Form 3160-5
(June 2019)

8. Well Name and No.
GOLDEN GRAHAM 1 FED COM/705H

EOG respectfully requests an amendment to our approved APD for this well to reflect the following changes:

Golden Graham 1 Fed Com 764H (FKA 705H) API #: 30-015-48317

Revised Wellbore

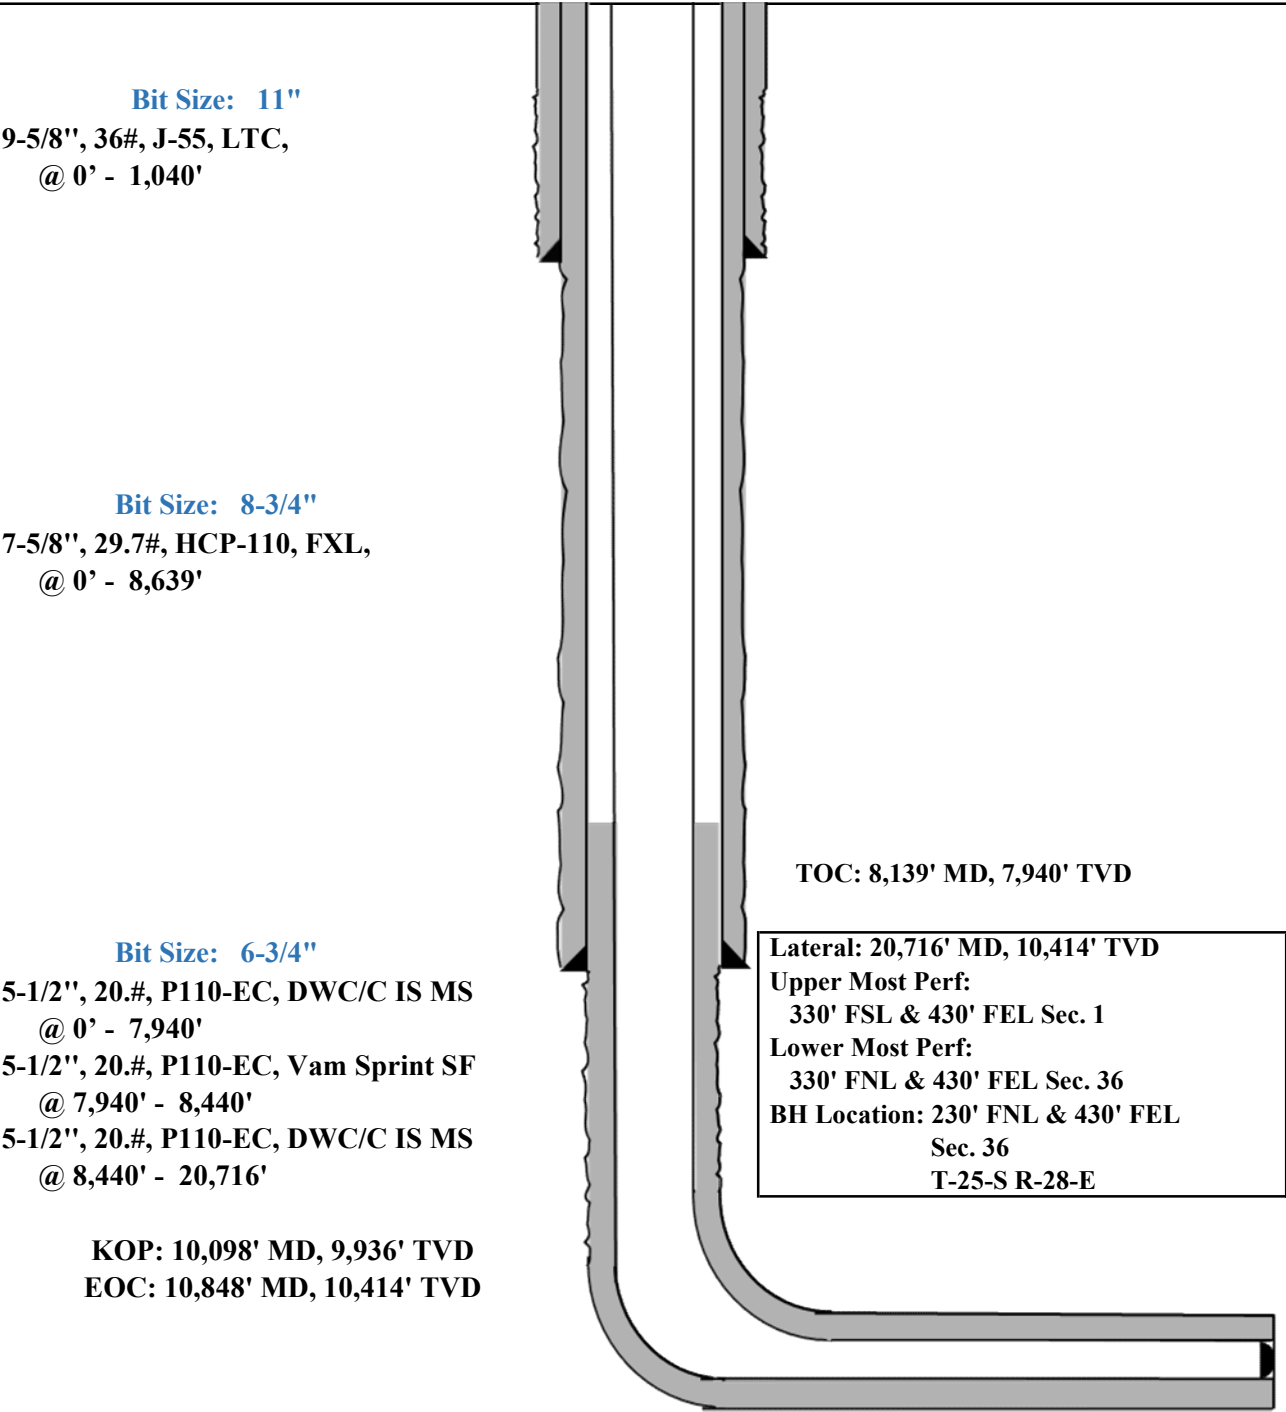
Change name from Golden Graham 1 Fed Com 705H to Golden Graham 1 Fed Com 764H.

Change SHL from T-26-S, R-28-E, Sec 1, 542' FSL, 1266' FEL, Eddy Co., NM, to T-26-S, R-28-E, Sec 1, 574' FSL, 1276' FEL, Eddy Co., N.M.

Change BHL from T-25-S, R-28-E, Sec 36, 230' FNL, 1160' FEL, Eddy Co., NM, to T-25-S, R-28-E, Sec 36, 230' FNL, 430' FEL, Eddy Co., N.M.

Change target formation to Wolfcamp M2.

Update casing and cement program to current design.

Golden Graham 1 Fed Com 764H

574' FSL
1276' FEL
Section 1
T-26-S, R-28-E
